Subject: AP1000 COL Standard Technical Report Submittal of APP-GW-GLN-019, Revision 2 (TR 103)

The changes within this Technical Report are a compilation of approved design changes to AP1000 Fluid Systems that have not previously been submitted under individual header. This document is sectioned to identify Fluid System changes that have been approved by the Westinghouse Change Control Board, that have not been submitted in previous Technical Reports, and that have had a direct impact on the Design Control Document (DCD). These are predominantly minor changes in system designs that are due to the progression of the detailed design. Each change will be individually identified within this document. The description of these changes can be found within Section II of this document. Additionally, not all of the changes described within this document have been incorporated into Rev. 16 of the AP1000 Design Control Document. The changes to R16 are detailed on pages 144 to 149.

Title: Fluid System Changes

Figure 6.3-2(Sheet 2)
Passive Core Cooling System
Piping and Instrumentation Diagram

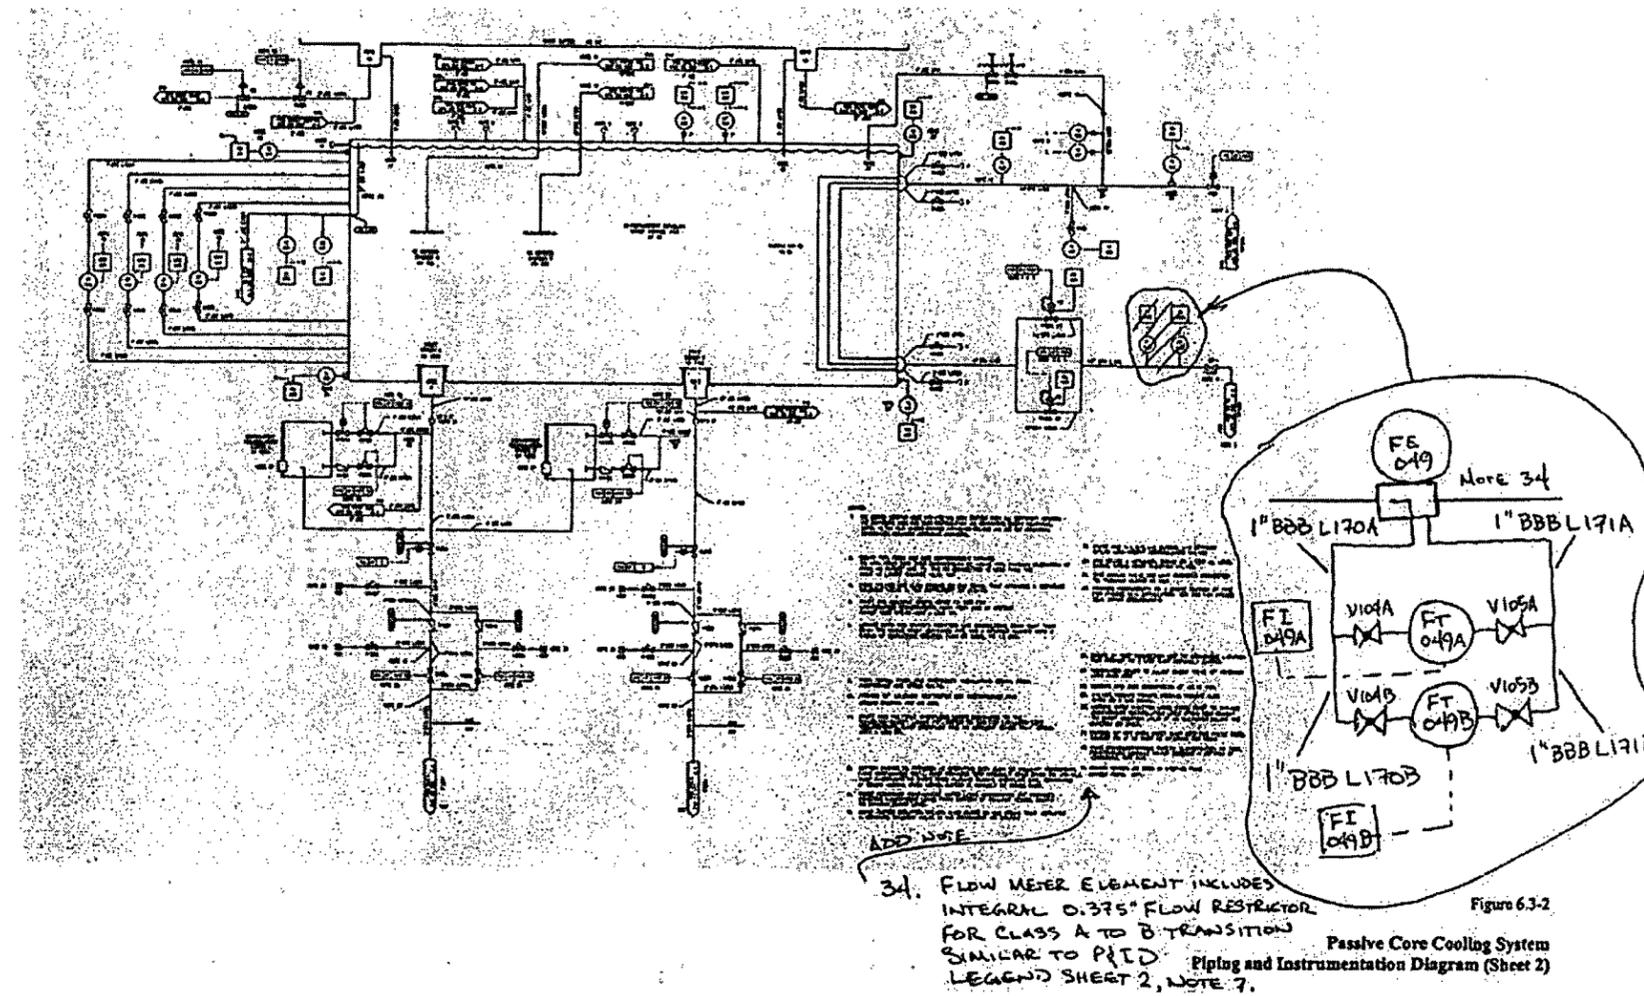
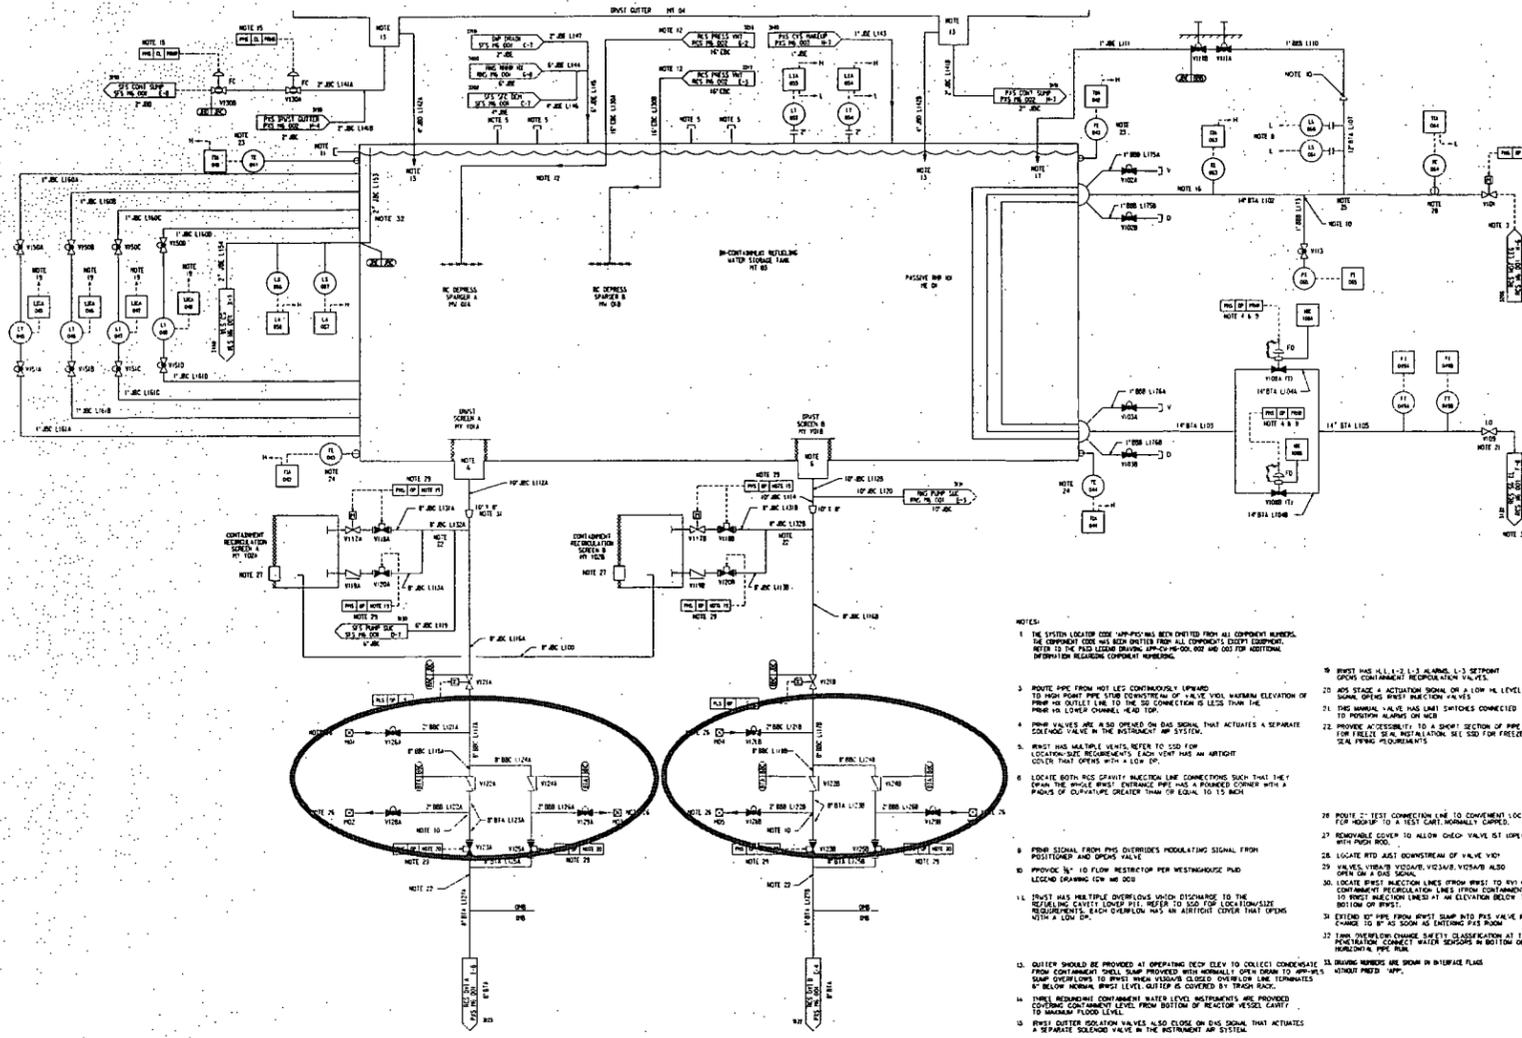
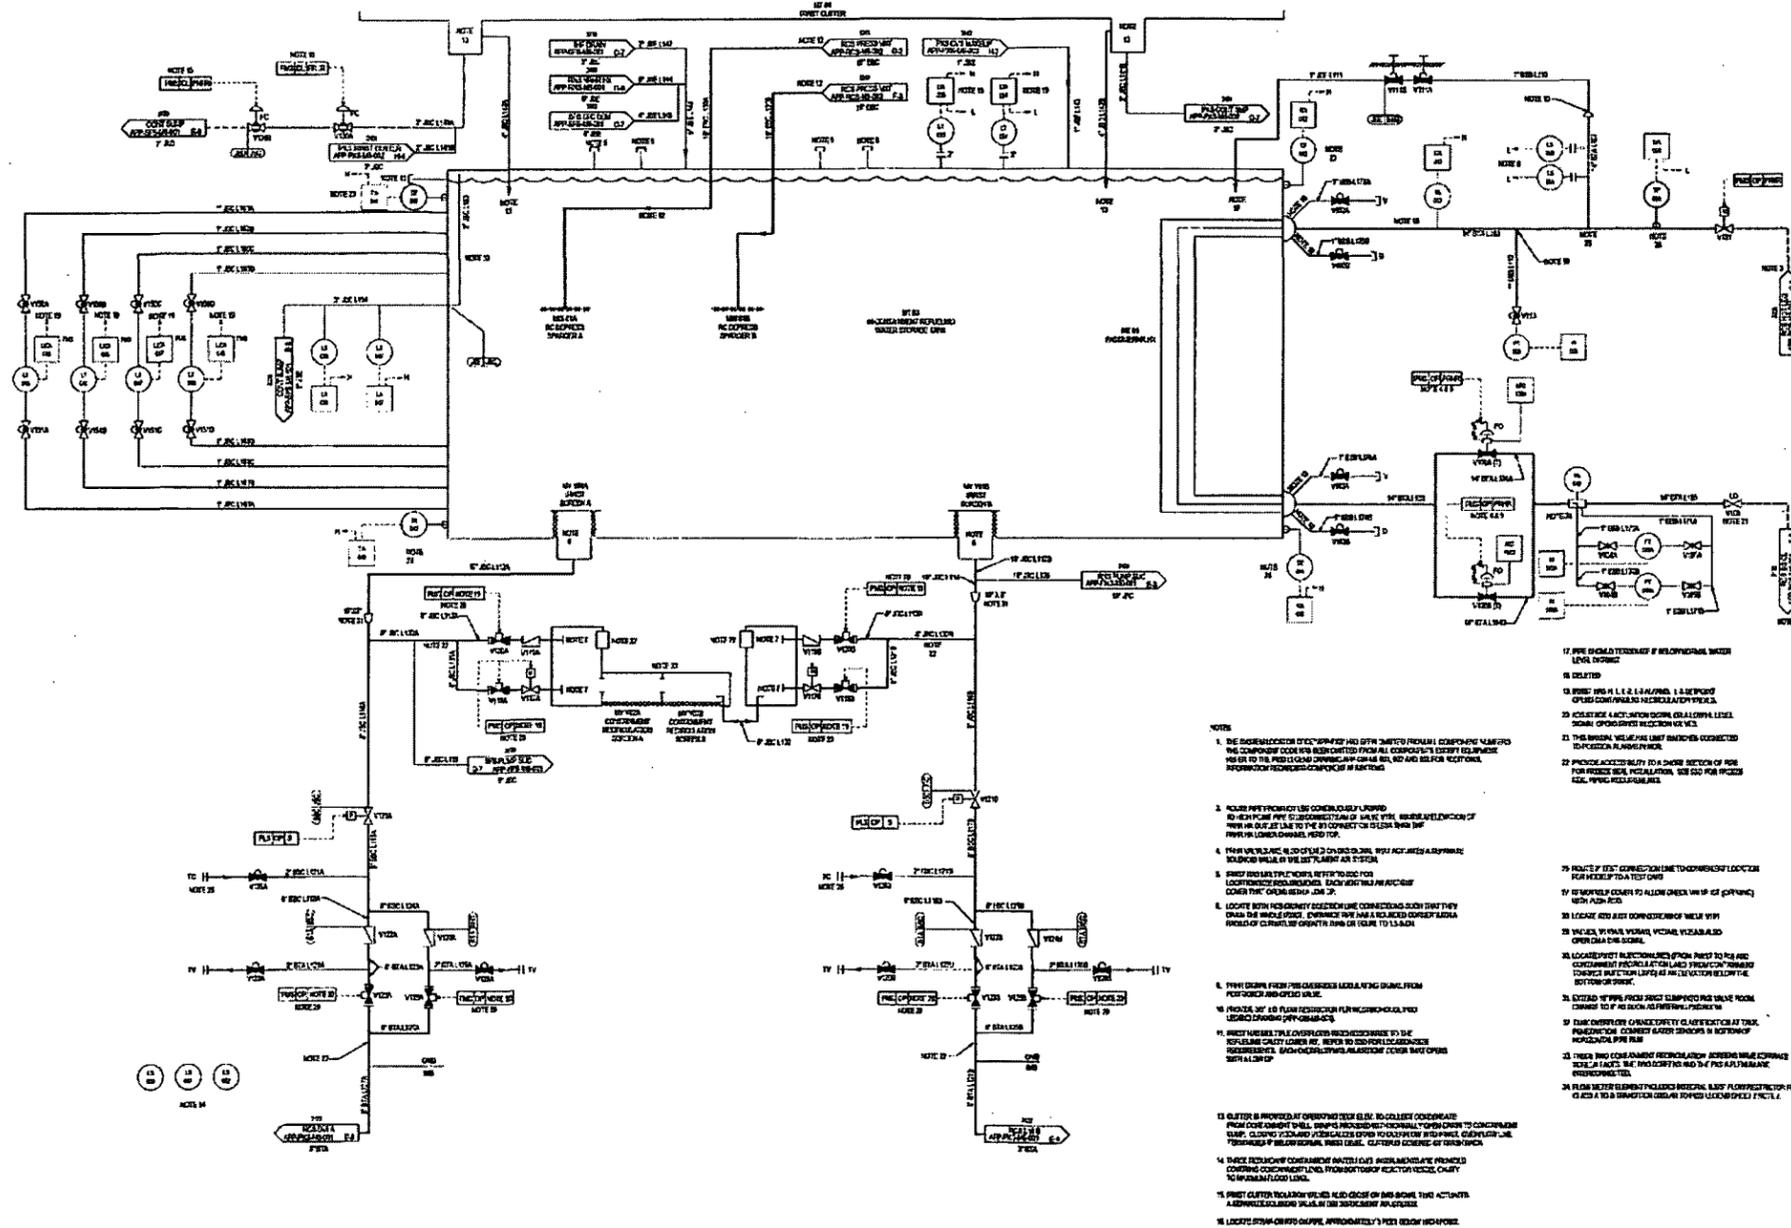
The previous Passive Containment Cooling System (PCS) DCD Figure 6.3-2 had the recirculation heaters positioned downstream of the chemical addition tank. However, the recirculation heater has been moved upstream of the chemical addition tank in the current plant model. This change was made to accommodate a horizontal heater as opposed to a vertical heater. In the new configuration chemical solution is no longer being added and immediately circulated through the heater. This will promote better mixing of the chemical additive since it is being added to water which is already hot. Also, the piping connection to the heater is now flanged; previously, the heater connections were welded.

The PCS DCD figure also needed to be modified to show the tank's chemical addition line as an independent connection. The Figure showed a single inlet into the tank; however, the tank actually has separate connections for the chemical additive and water. The independent connection ensures that any chemical addition flows into the tank and not into the downstream piping.

The previous DCD figure also showed a connection between lines L029 and L051 when no such connection existed in AP1000. Line L029 actually connects to line L048. Finally, the connecting tees between lines L080 and L064, L046 and L057, and L051 and L048 were misrepresented on the figure.

Both flow measurements, PXS-049A and -049B, may be made using a single primary element. The cross-sectional area of the installed primary element would be a small fraction of the pipe cross-sectional area, and would produce a relatively small pressure drop. A fluid system evaluation has been performed to evaluate the acceptability of the additional pressure drop imposed by the Annubar™ element. The pressure drop can be accommodated by using some of the margin originally included in the piping system calculations to allow for pipe routing changes. Pipe routing is not expected to change significantly now, and it was not necessary to eliminate the margin entirely. The expected pressure drop is acceptable, and will not require a change to the safety analysis.

Figure 9.1.6 (Sheet 1 of 2)
 SFS Pump Common Suction Pipe (L050) and RCS Engineering Flow Diagram

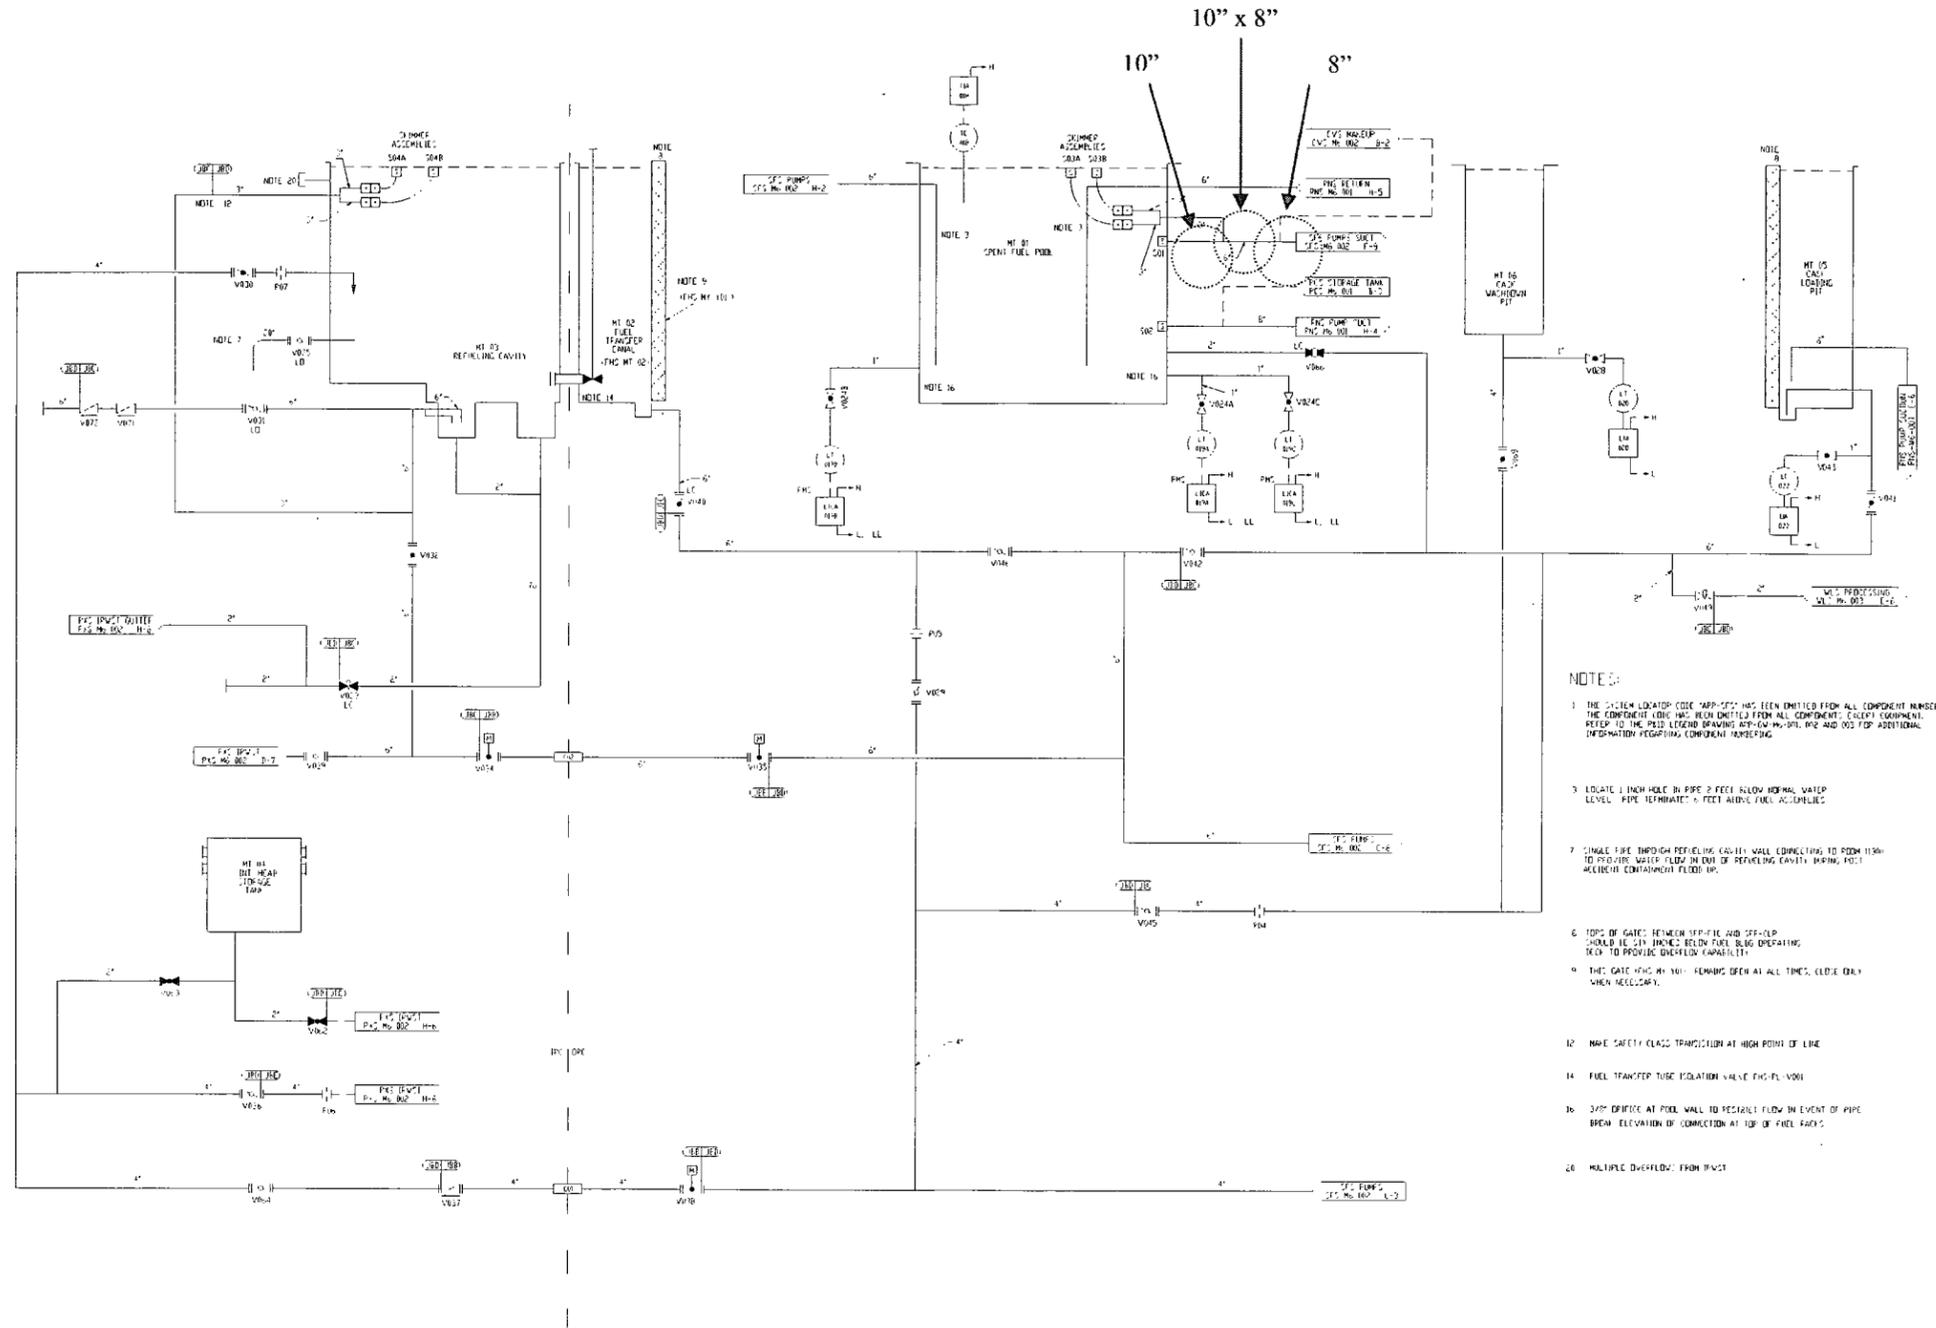
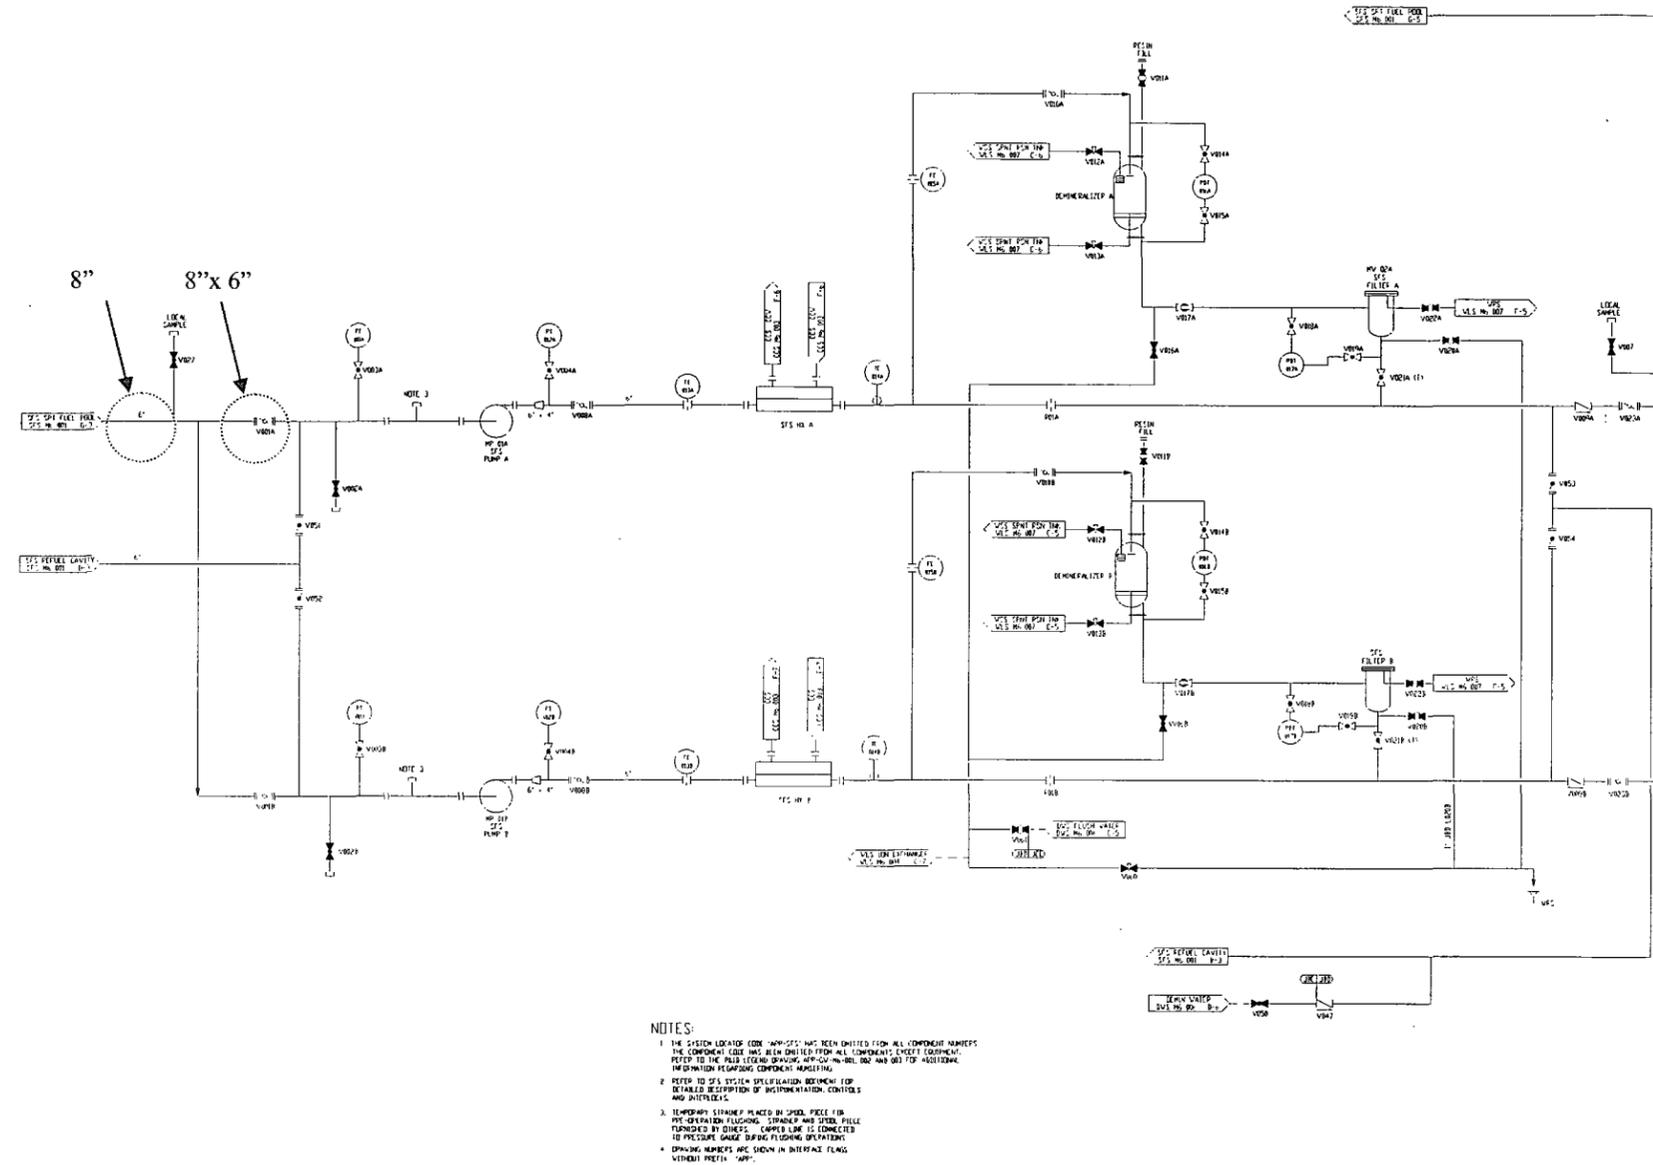
This change has increased the SFS common suction pipe from 6 inch, Sch 40 to 10 inch, Sch 40 from the SFP to the penetration at the SFS pump room. The line is then reduced from 10 inch, Sch 40 pipe to 8 inch, Sch 40 pipe from the pump room penetration to line L001A. The remainder of the SFS suction piping will remain 6 inch, Sch 40. The previously specified pipe diameter of 6 inches resulted in large pressure drops which would have caused cavitation in the SFS pump suction lines when the SFP temperature is elevated. This large suction line pressure drop created an unacceptable situation in which SFP cooling with the SFS pumps couldn't have been restored following a temporary loss of SFP cooling. The increase in line size will reduce the pressure drop in the suction line and increase the NPSHa to appropriate levels for proper pump operation.

This change has increased the size of line the SFS pump common discharge line from 6-inch, Sch 40 to 8-inch, Sch 40. This change, combined with the reduced ΔP in the pump suction line, decreases the pump required head. This will lower the pump horsepower by approximately 35% at normal operating conditions.
